Sonoma County Planning Commission STAFF REPORT

FILE:UPE19-0083DATE:June 17, 2021TIME:1:05 pmSTAFF:Marina Herrera, Project Planner

| Property Owner: | Santa Rosa Horn Investors, LLC |
|------------------------------|--|
| Description: | Request for a Use Permit for an Intermediate Freestanding Commercial Telecommunications Facility, including a 96-foot high faux tree monopole (mono-pine), associated ground equipment cabinet and a 30KW generator and 190 gallon diesel tank for the purpose of emergency power, to be located within a 1,600 square foot lease area, enclosed by a six foot high fence on a ±21 acre parcel. |

Applicant's Viewpoint #2 (monopole) (Santa Rosa Avenue, ~600 feet northwest of site)

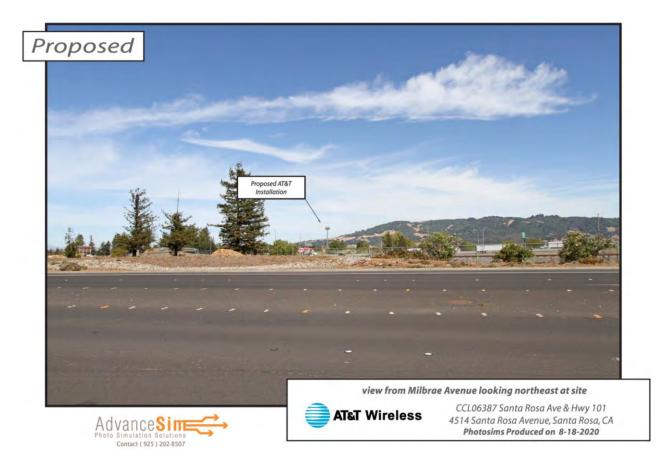
2. <u>Applicant's Viewpoint #2</u> is about <u>600 feet to the northwest</u>, on Santa Rosa Avenue. From about this point, southbound travelers on Santa Rosa Avenue will gradually approach the tower with their view of the tower only partially obstructed by low trees and overhead power lines. However, like northbound travelers, southbound travelers will experience an increasingly imposing structure, and finally will pass by it <u>at a distance of less than 100 feet</u>. Yet the applicant has prepared no other simulations from Santa Rosa Avenue.

F. <u>The Committee Should Give Great Weight to the Project's Impact on Users</u> of the North Rohnert Park Trail.

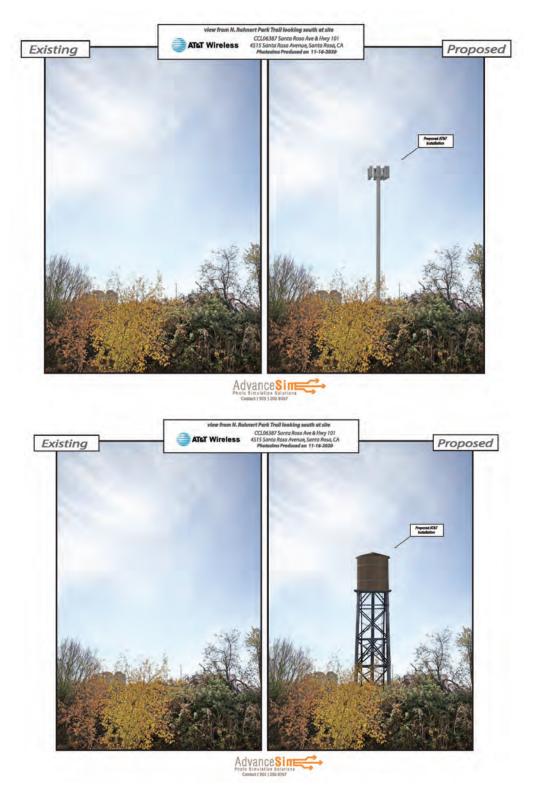
Just 100 feet north of the tower site is a public nature trail called North Rohnert Park Trail, which runs along a canal operated by the Sonoma County Water Agency. The trail runs from Roberts Lake Road, east approximately 1.5 miles to Snyder Lane. Other than low brush and vegetation, there are no obstructions along the trail that would block views of the proposed tower.

The users of a public trail of this type deserve special consideration in any review of the project. Whether it is an undisguised 86-foot tall tower or an 88-foot tall faux "water tank," the project will forever alter the experience of using this nature trail.
